# PEER REVIEW OF SACRAMENTO VALLEY FINITE ELEMENT GROUNDWATER MODEL (SACFEM)

U.S. Bureau of Reclamation

Prepared by:  WRIME

October 2011

Figure 8. Groundwater Pumping for 2000 (normal hydrological conditions).  
(Some of the areas with excessive groundwater pumping are identified with red circles.)

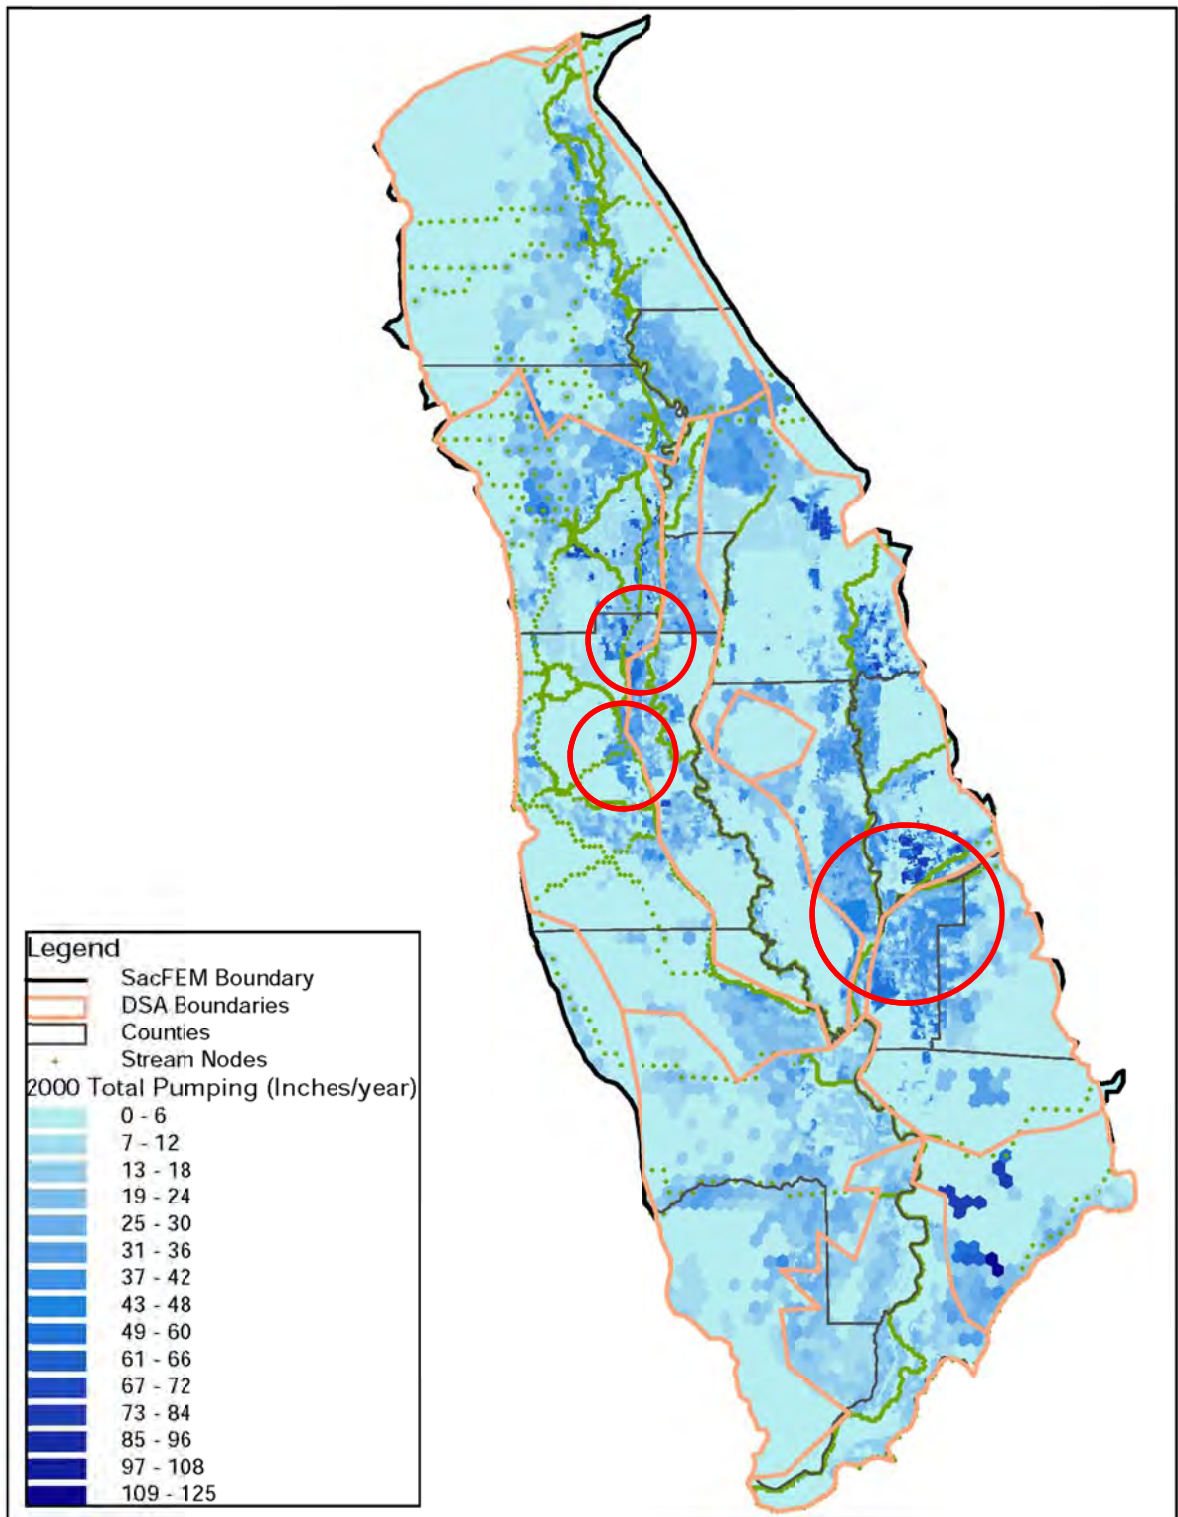
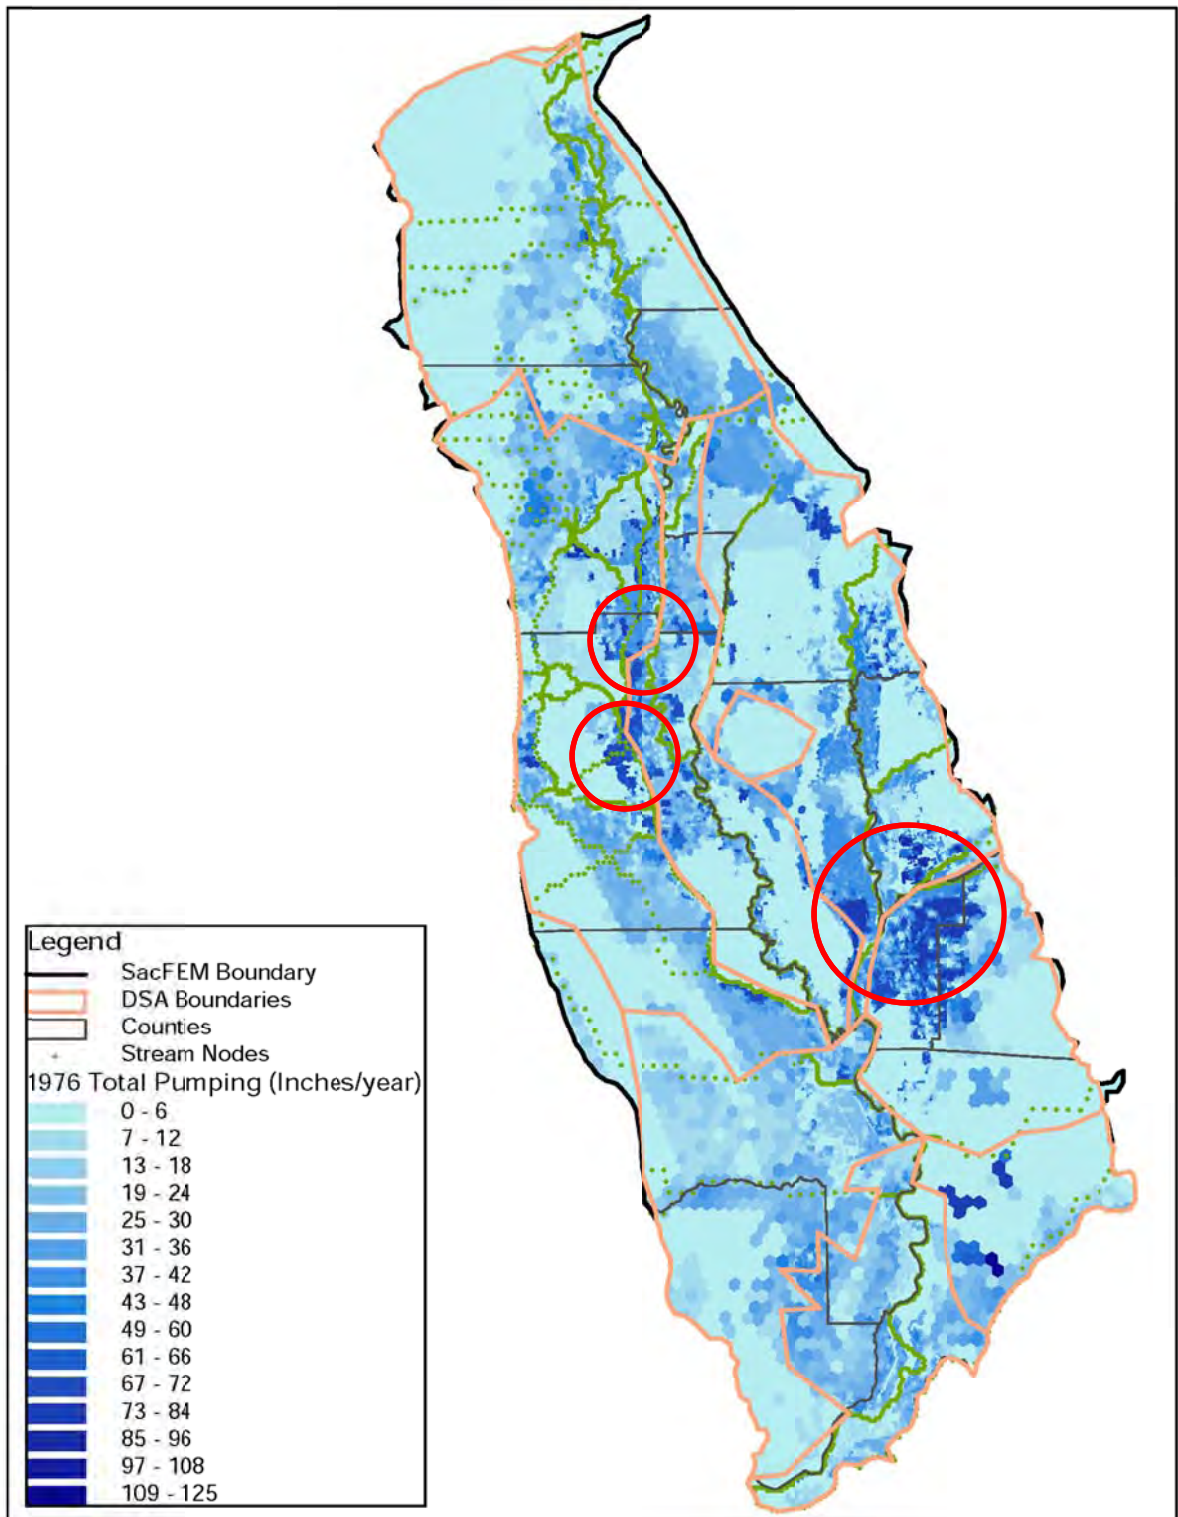
Agricultural water demand estimates vary based on hydrological conditions. As a result, agricultural groundwater pumping estimates are highest in dry years and lowest in wet years. Groundwater pumping distributions for normal, dry, and wet hydrological conditions are presented in Figures 8, 9, and 10, respectively. The groundwater pumping maps for years 1976 (Figure 8) and 2000 (Figure 9) show excessive pumping in some areas where surface water appears to be available (Figures 7). In contrast, groundwater pumping distribution for 1983 (Figure 10) is consistent with the water supply mix map (Figure 7). Some of the areas with excessive pumping are marked on Figures 8 and 9.

Updating the land use and crop acreage data for historical conditions will result in changes in agricultural demand rates. It is recommended to verify the agricultural demand calculations against the update of the land use and crop acreage data. It is recommended to use available historical surface water delivery data for calculation of historical agricultural groundwater pumping. Historical agricultural groundwater pumping rates should be re-estimated based on historical agricultural demand and surface water delivery data.

Figure 12. Distribution of IDC Deep Percolation Rates from Precipitation

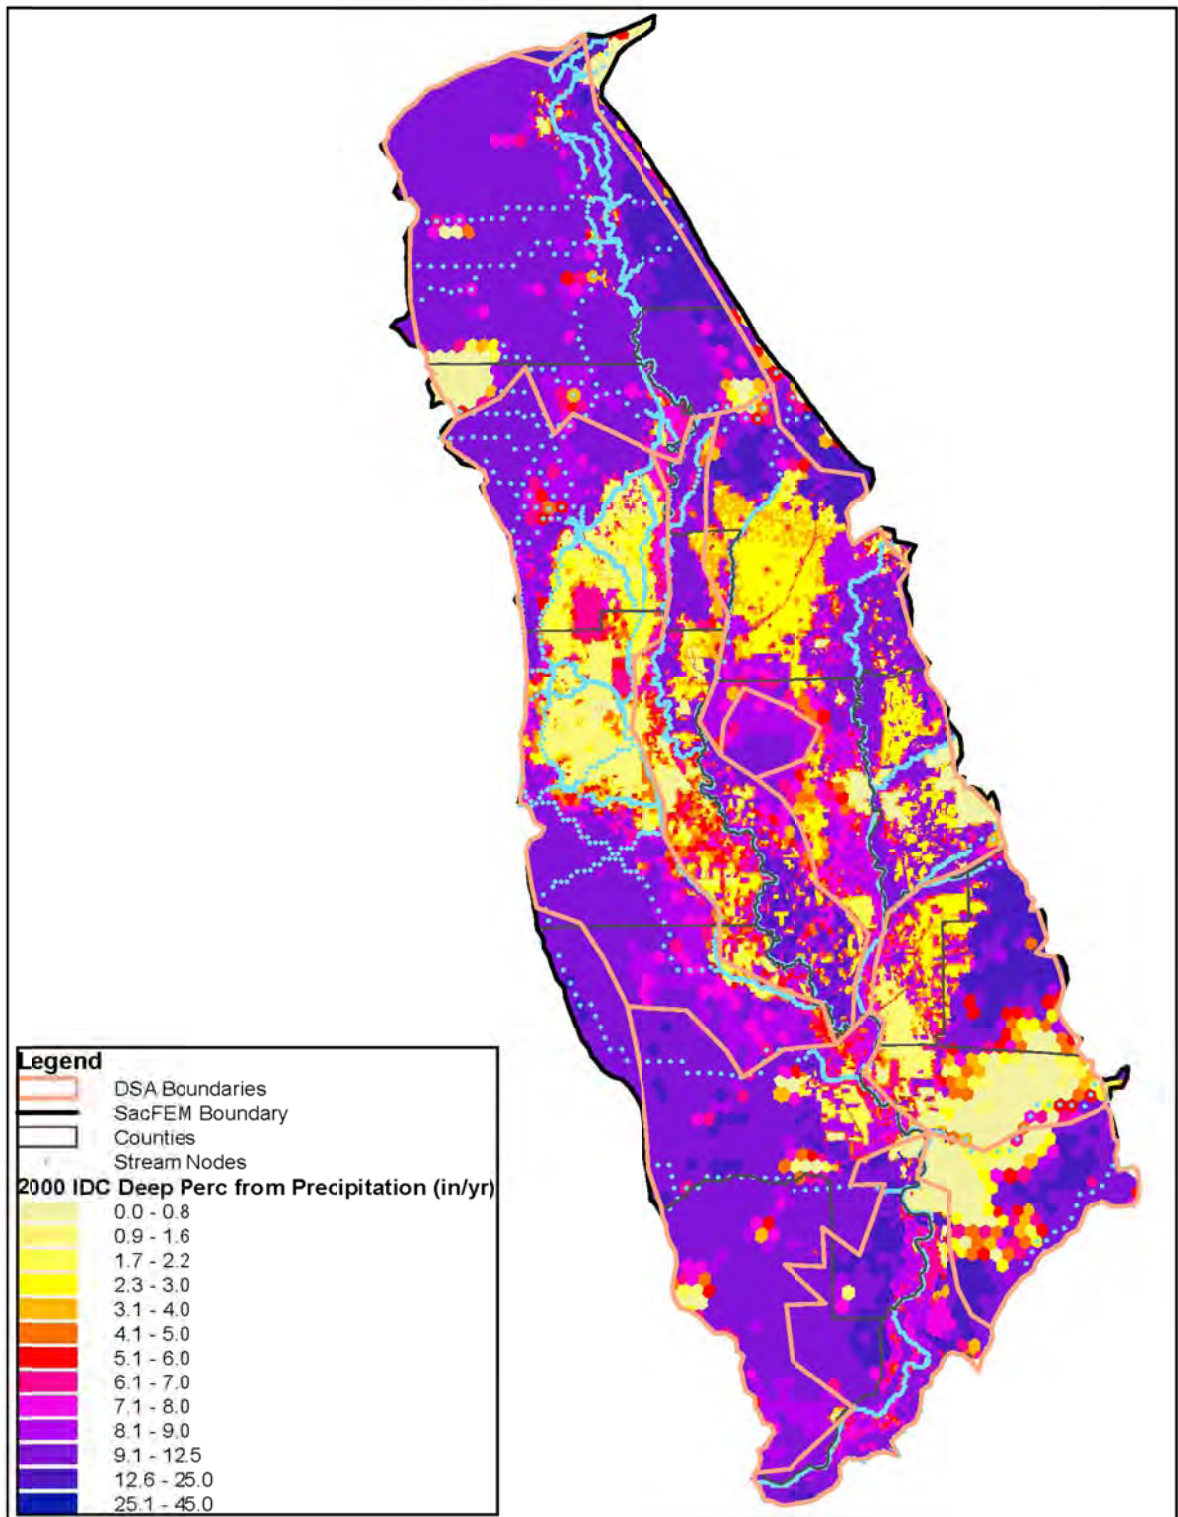
Deep percolation rate, in part, depends on hydrological soil types (Figure 1). Soil type A has the highest deep percolation rates and soil types D has the lowest deep percolation rates for the same precipitation rates. Distribution of hydrological soil types in the Sacramento Valley is presented in Figure 11. Distribution of the IDC model deep percolation rates from precipitation is presented in Figure 12. Estimates of deep percolation rates from precipitation are excessive, as high as 45 inches per year in some areas. Additionally, distribution of deep percolation from precipitation is not consistent with soil type and precipitation distribution.

Figure 13. Distribution of ICD Deep Percolation Rates from Applied Water

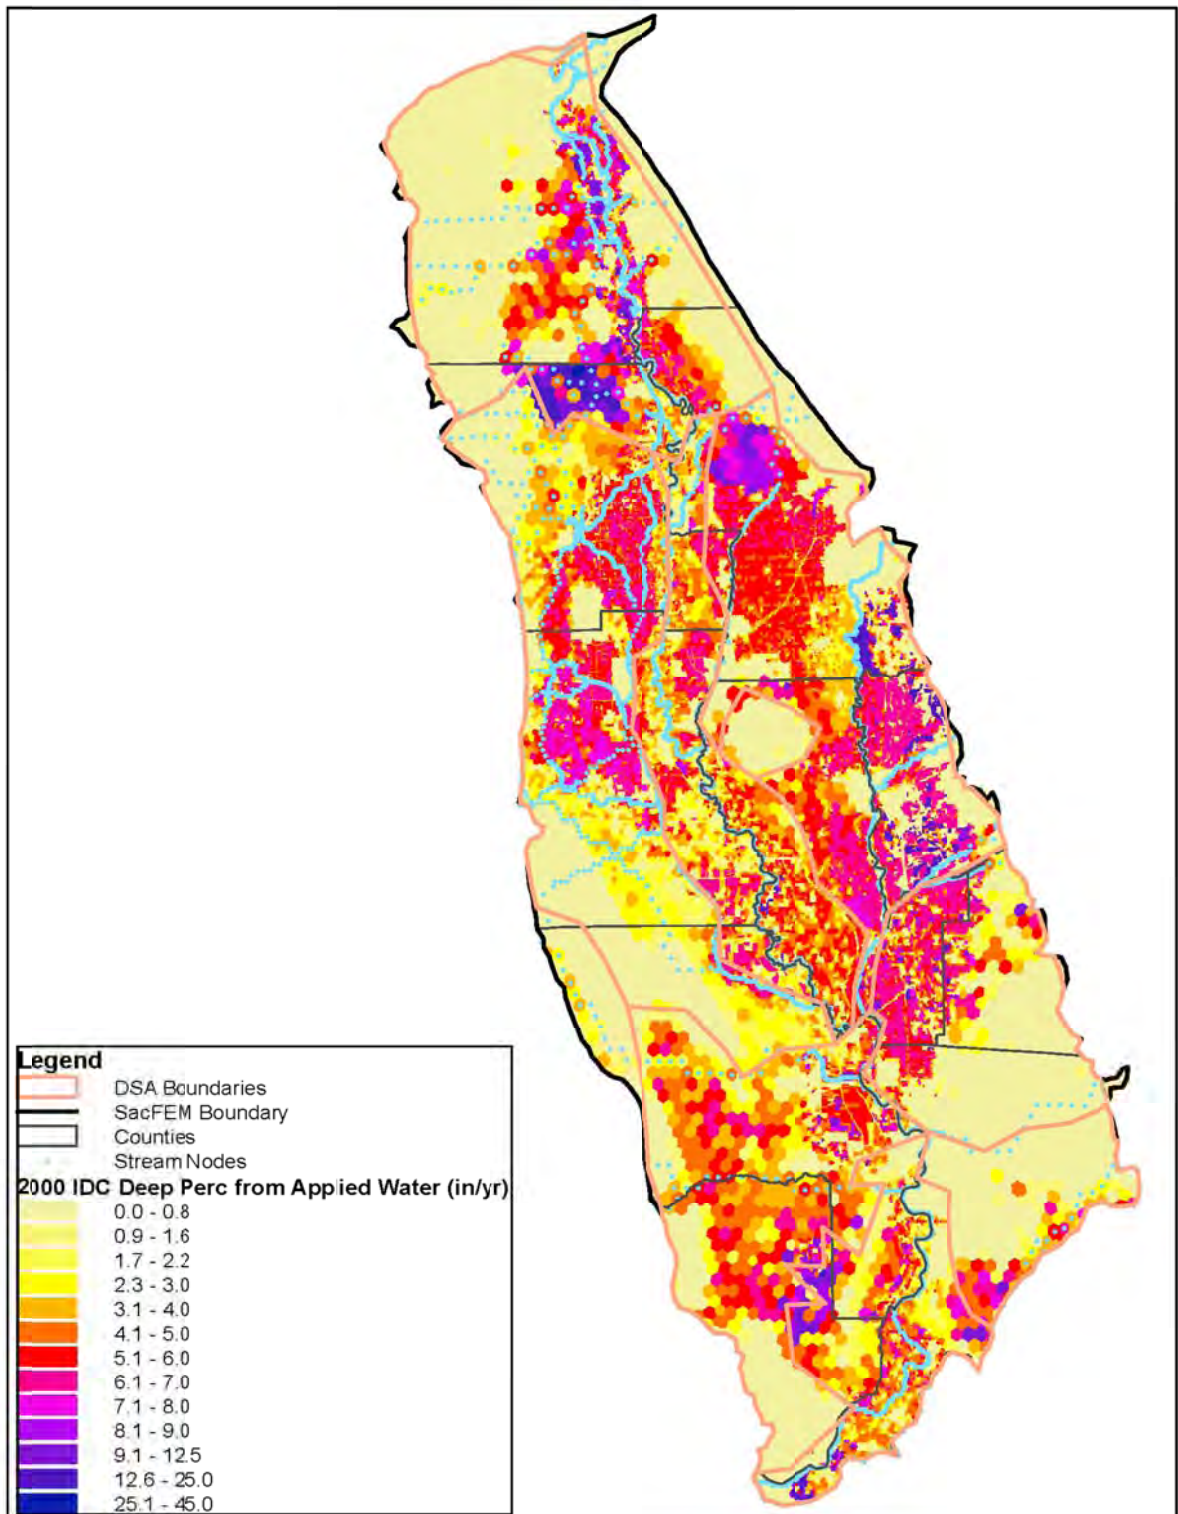
Distribution of the IDC model deep percolation rates from applied water is presented in Figure 13. The IDC model estimates excessive deep percolation rates from applied water and the distribution of deep percolation is not consistent with soil type. Distribution of the IDC model total deep percolation rates from precipitation and applied water is presented in Figure 14. The IDC model estimates excessive deep percolation rates, as high as 45 inches per year, with a distribution that is not consistent with soil type and surface water distribution.
